**From:** WILLIFORD Dennis (AREVA) [Dennis.Williford@areva.com]  
**Sent:** Wednesday, August 31, 2011 5:47 PM  
**To:** Tesfaye, Getachew  
**Cc:** BENNETT Kathy (AREVA); DELANO Karen (AREVA); ROMINE Judy (AREVA); RYAN Tom (AREVA); KOWALSKI David (AREVA)  
**Subject:** Response to U.S. EPR Design Certification Application RAI No. 385, FSAR Ch. 9, Supplement 22  
**Attachments:** RAI 385 Supplement 22 Response US EPR DC.pdf  
**Importance:** High

The attached file, "RAI 385 Supplement 22 Response US EPR DC.pdf" provides technically correct and complete FINAL responses to Questions 09.01.04-15, 09.01.04-16 and 09.01.04-17.

**QUESTIONS for Balance of Plant Branch 1 (AP1000/EPR Projects) (SBPA)**

**Question 09.01.04-15:****Follow-up to RAI 131, Questions 09.01.04-5 and 09.01.04-7**

Figure 9.1.4-9—Loading Pit Penetration Assembly Seals

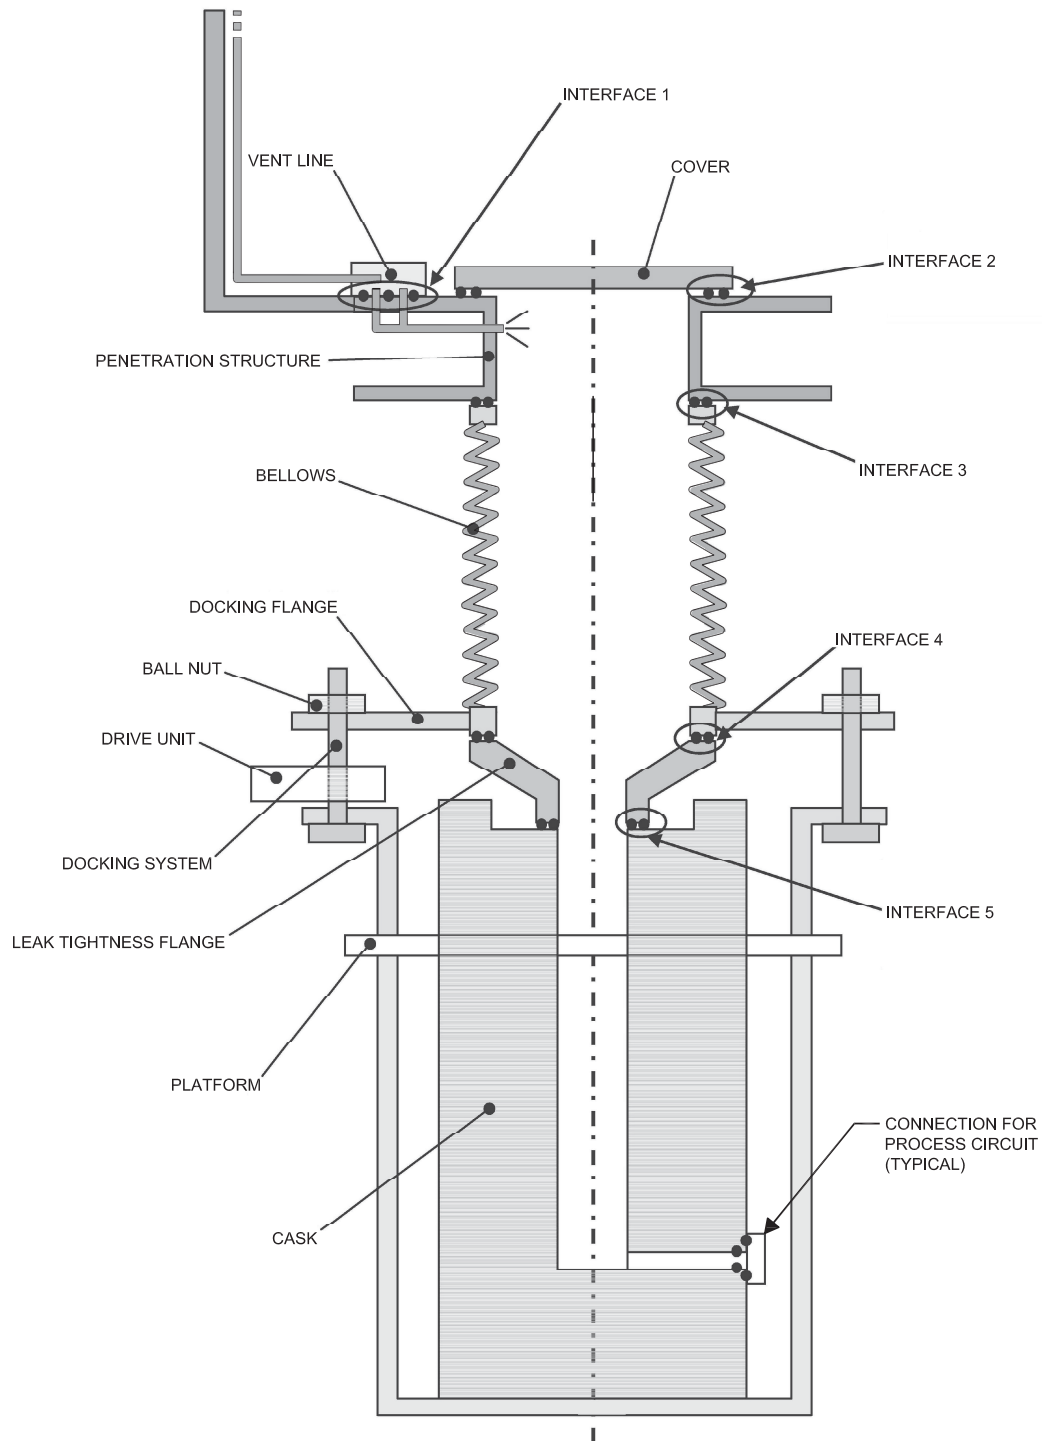
In response to RAI 9.1.4-05 (RAI #131, Supplement 4) and RAI 9.1.4-07 (RAI #131, Supplement 5), the applicant proposed to remove the general description and details regarding operation of the spent fuel cask loading and spent fuel cask transfer facility from the FSAR and redefine the scope of U.S. EPR design certification to include only the cask loading pit penetration assembly (part of the spent fuel cask transfer facility) and covers. The response stated that U.S. EPR FSAR Tier 1, Section 2.2.8 and Table 2.2.8-1, and Tier 2, Section 9.1.4, and Section 14.2.12.3.16, will be revised accordingly, including deletion of Tier 2, Figure 9.1.4-7 that showed a simplified sketch of the spent fuel cask transfer facility. The RAI response also stated that the cask handling operations will be covered under a 10 CFR Part 72 license application once a cask design is selected.

The staff considers the applicant's response to RAI 9.1.4-05 and RAI 9.1.4-07 to be unacceptable. Spent fuel cask loading is considered a major portion of fuel handling system (FHS) to demonstrate the safe handling of spent fuel. The applicant has not provided sufficient details to verify that the light load handling system (LLHS), cask handling and pool design meets the guidance of SRP Section 9.1.2, 9.1.3, 9.1.4 and applicable portions of SRP Section 9.1.5. In accordance with SRP Section 9.1.4, the LLHS is acceptable if the integrated design of the structural, mechanical, and electrical elements, the manual and automatic operating controls, and the safety interlocks and devices provide adequate system control for the specific procedures of handling operations, if the redundancy and diversity needed to protect against malfunctions or failures are provided, and if the design complies with applicable regulations. As indicated in SRP Section 9.1.4, the area of review includes review of the LLHS from receipt of new fuel to loading of spent fuel into the shipping cask, for compliance with requirements of GDC 2, 5, 61 and 62.

In accordance with 10 CFR 52.47 (a)(24), the applicant should either provide a full description of the spent fuel cask loading and spent fuel cask transfer facility in Chapter 9 of the FSAR or revise FSAR Section 1.8, "Interfaces with Standard Designs and Early Site Permits," to indicate that the spent fuel cask loading and spent fuel cask transfer facility is outside the scope of the EPR standard design and provide conceptual design information (CDI) of the spent fuel cask loading and spent fuel cask transfer facility in Chapter 9 of the FSAR.

U.S. EPR FSAR Tier 2, Section 9.1.4.2.2 will be revised to include this additional information about the cask loading pit seals and a new U.S. EPR FSAR Tier 2, Figure 9.1.4-9—Loading Pit Penetration Assembly Seals.

U.S. EPR FSAR Tier 2, Figures 9.1.4-9 and 9.1.4-10, and U.S. EPR FSAR Tier 2, Table 9.1.4-1 will be added as described in the response and indicated on the enclosed markup.
